THE GLEN AT WIDEFIELD FILING NO. 12
RESIDENTIAL SUBDIVISION CONSTRUCTION DRAWINGS
PREPARED FOR WIDEFIELD INVESTMENT GROUP

EPC STORMWATER REVIEW COMMENTS
IN ORANGE BOXES WITH BLACK TEXT

Kiowa Project No. 19016
May 3rd, 2023

GLEN AT WIDEFIELD NO. 12
Storm Sewer Plan - Laterals 'F' - Filing 12 Portion
Ref: Pennycrest Storm Trunkline
EL PASO, COUNTY, COLORADO

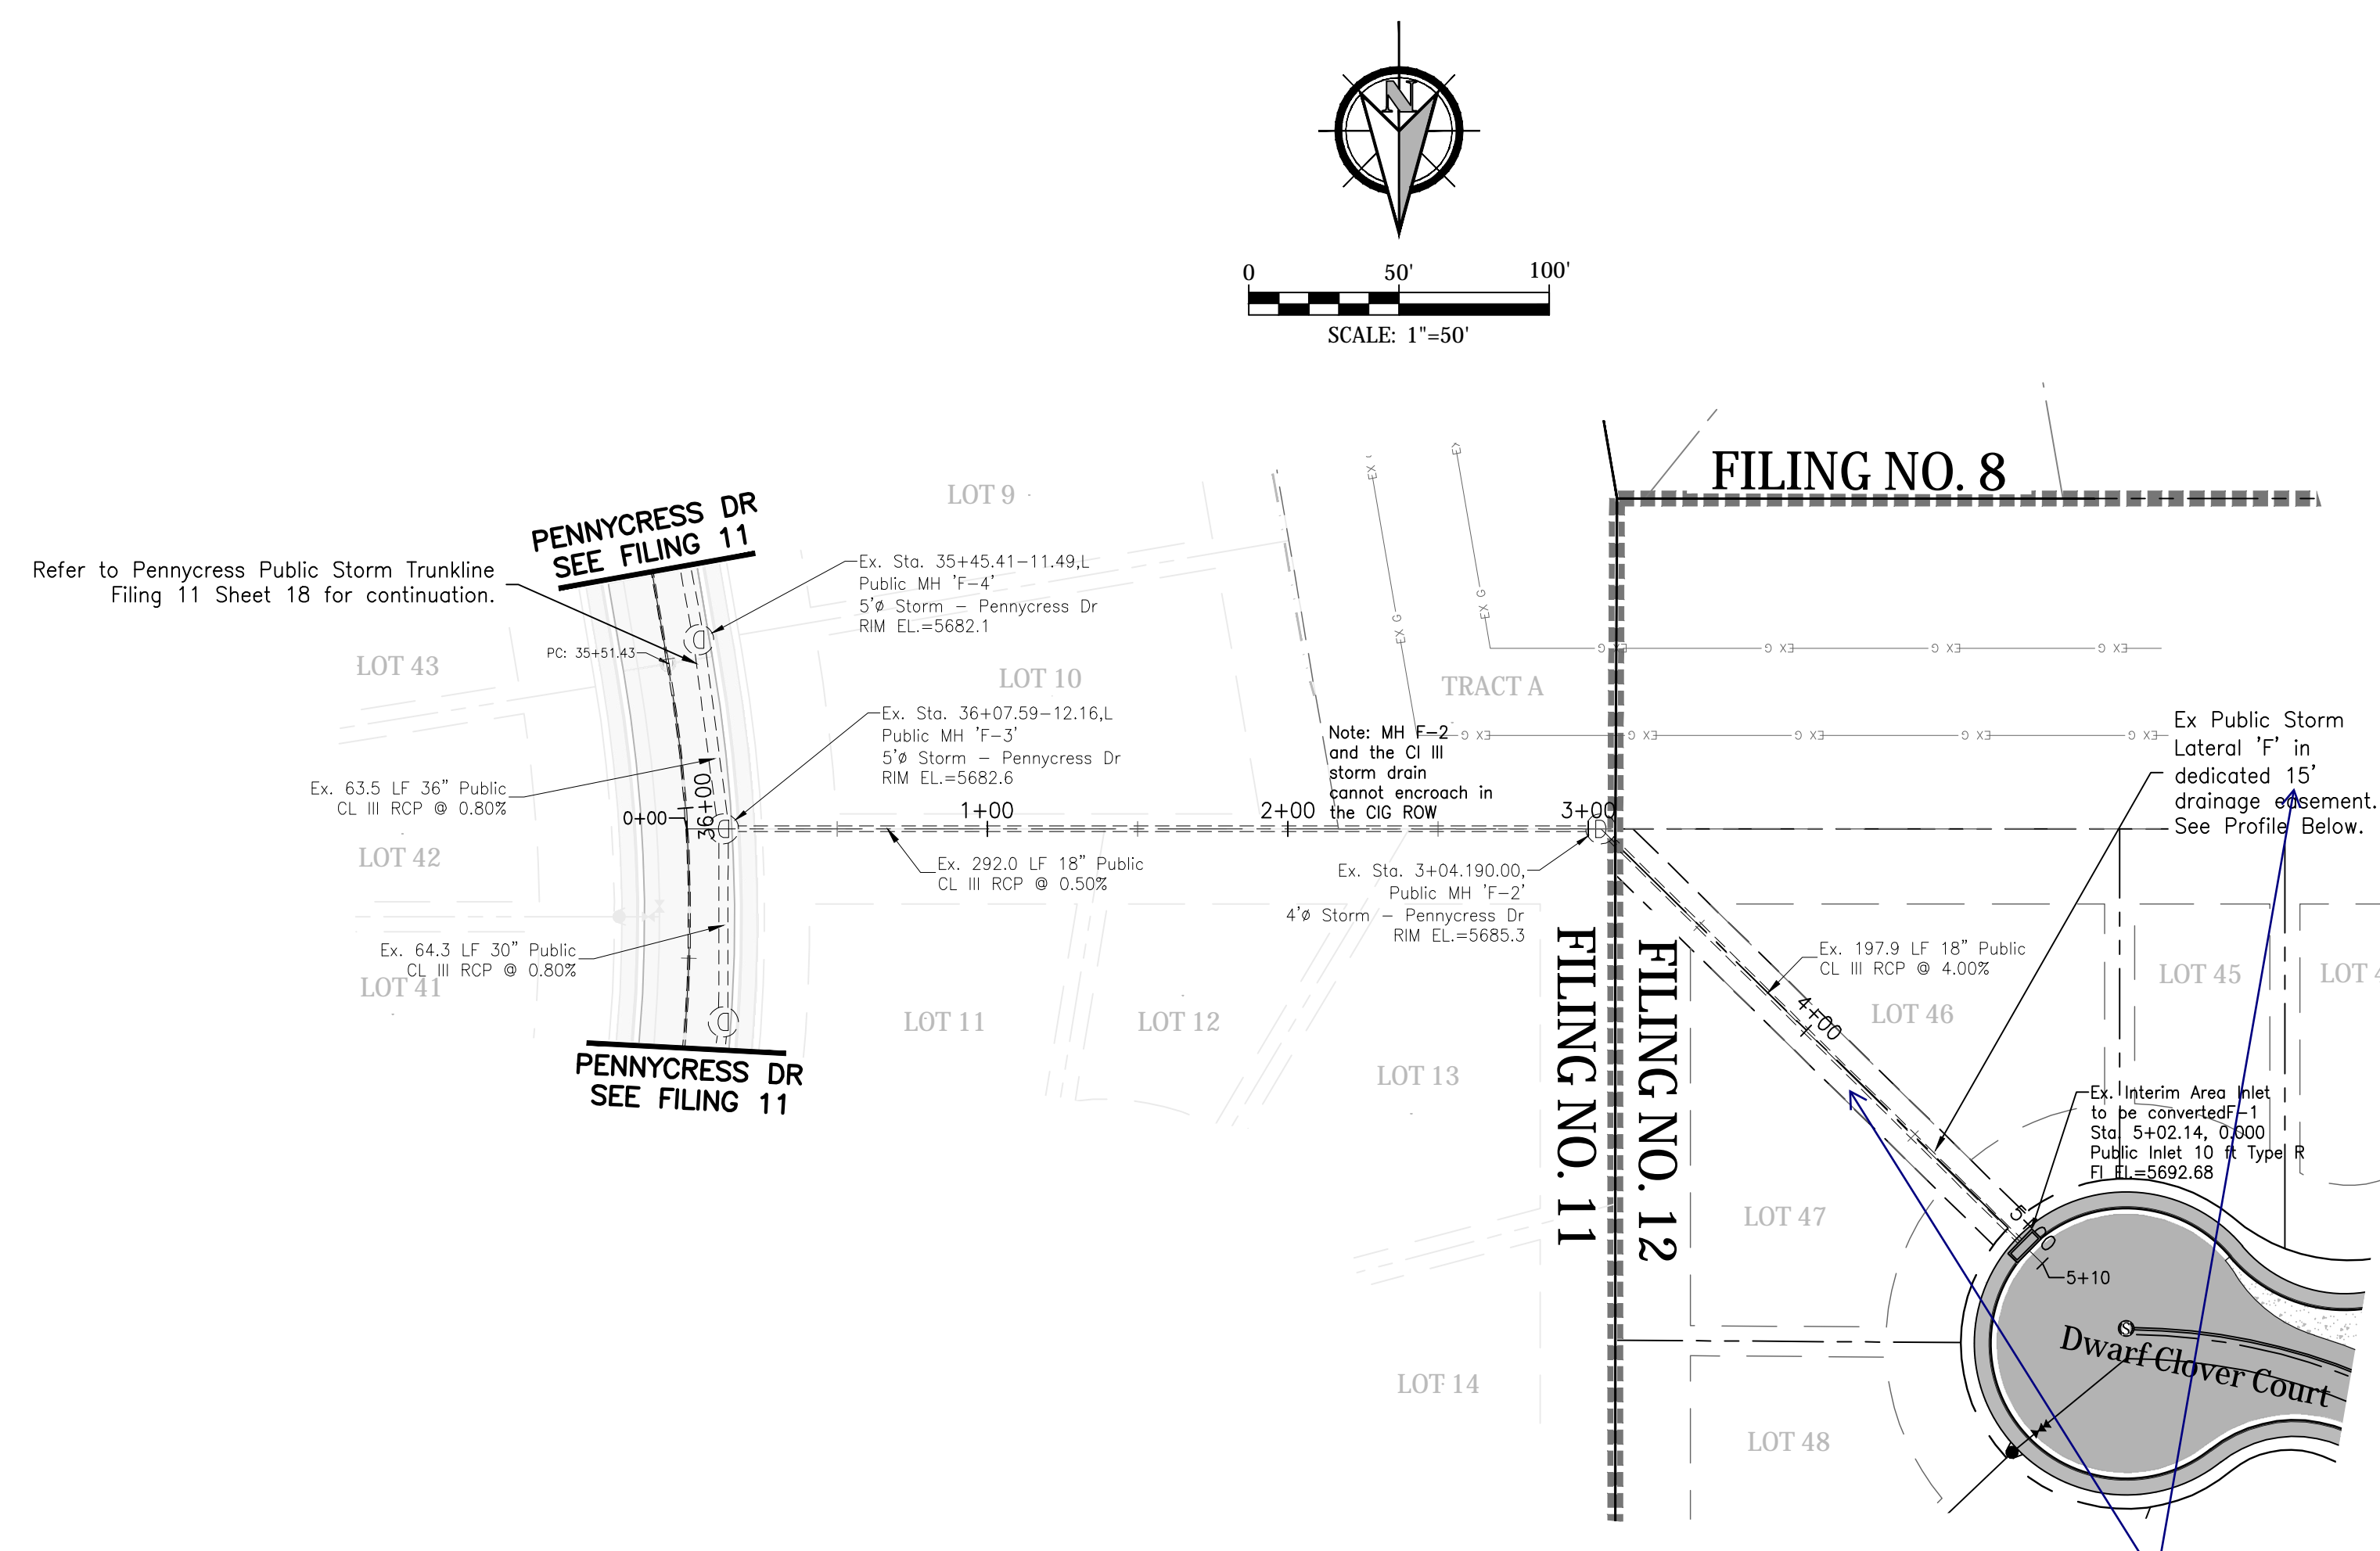
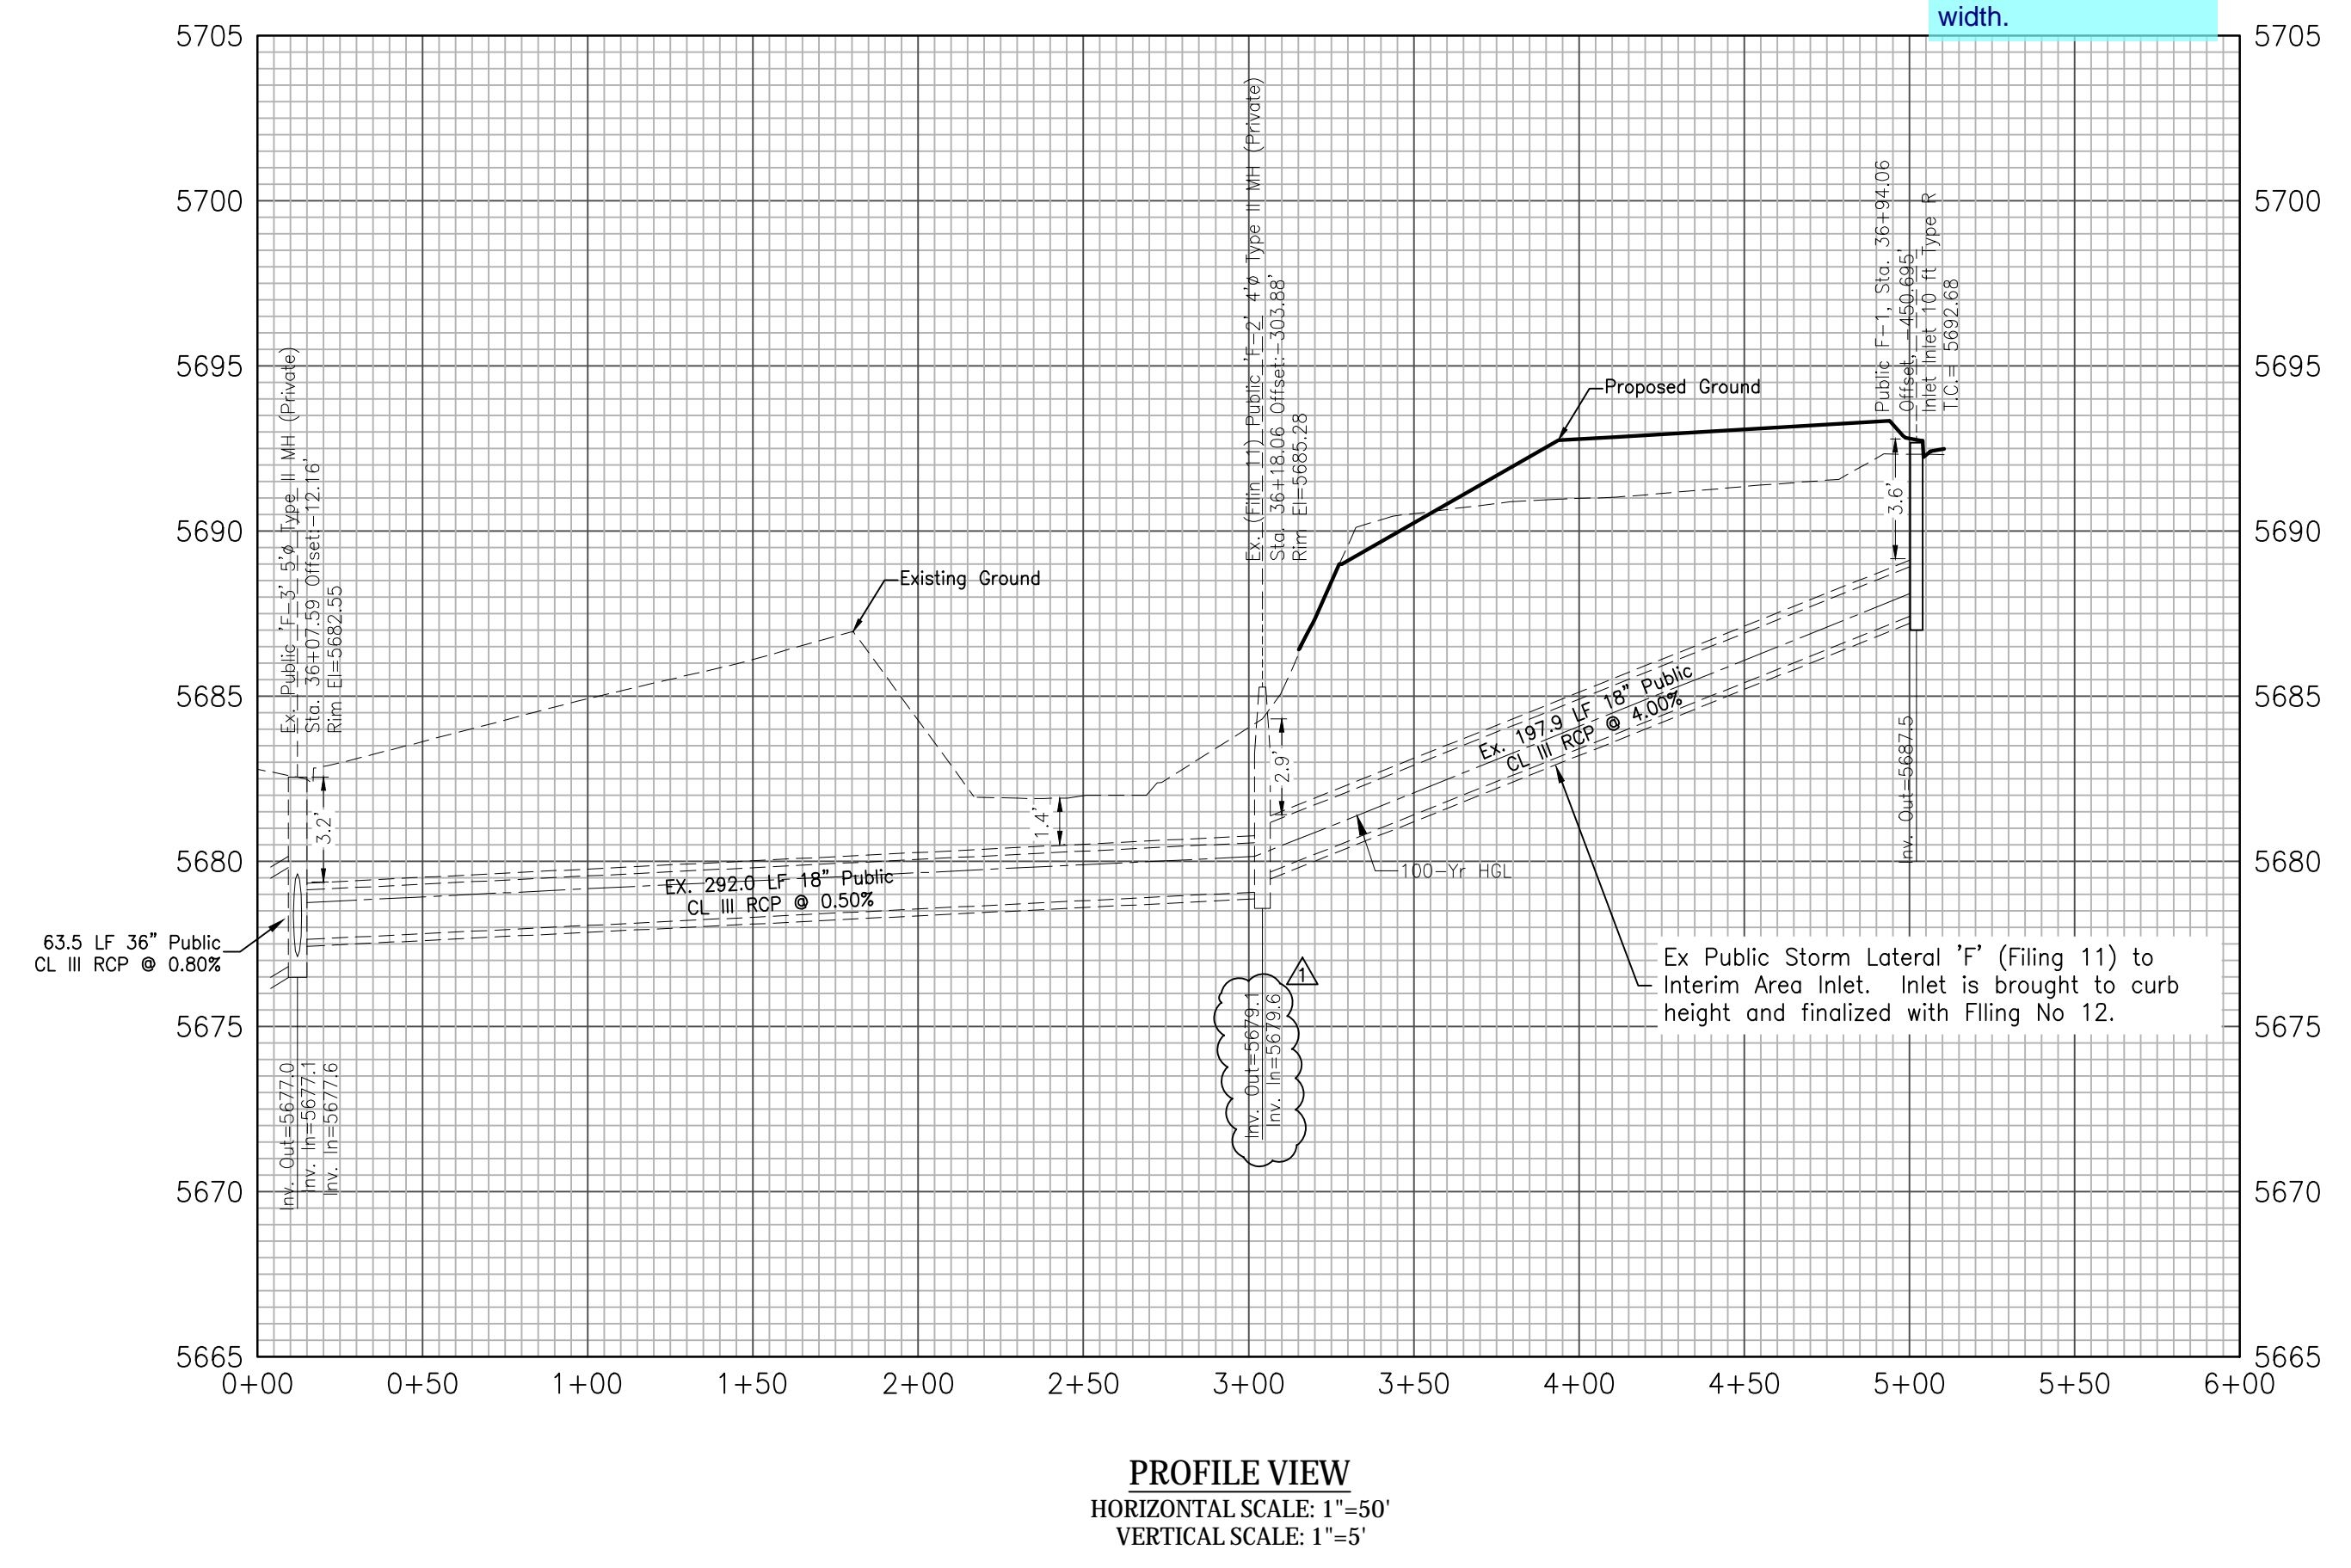
Review 2 comment:
 revise the easement to reflect 30' as shown on the plat.

Review 3:
 unresolved. Please revise the easement width.

GLEN AT WIDEFIELD NO. 12
Grading, Erosion & Sediment Control Cover Sheet
Filing 12 (Entire Site)
EL PASO, COUNTY, COLORADO

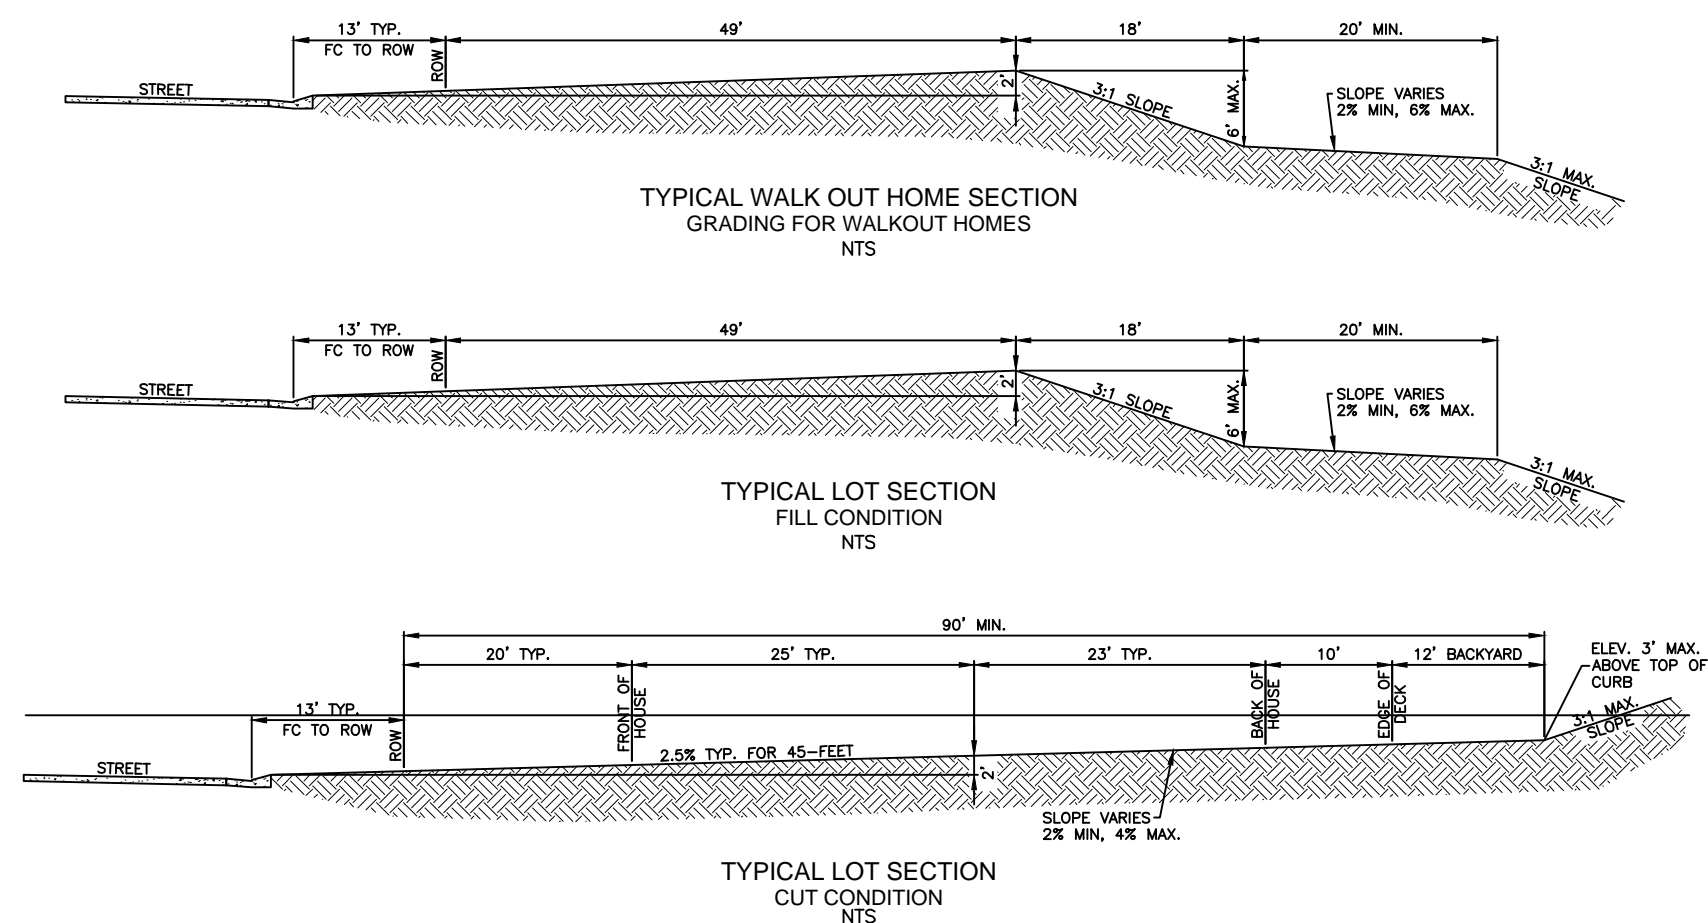
update to reflect the correct soils report for this filing. unresolved.
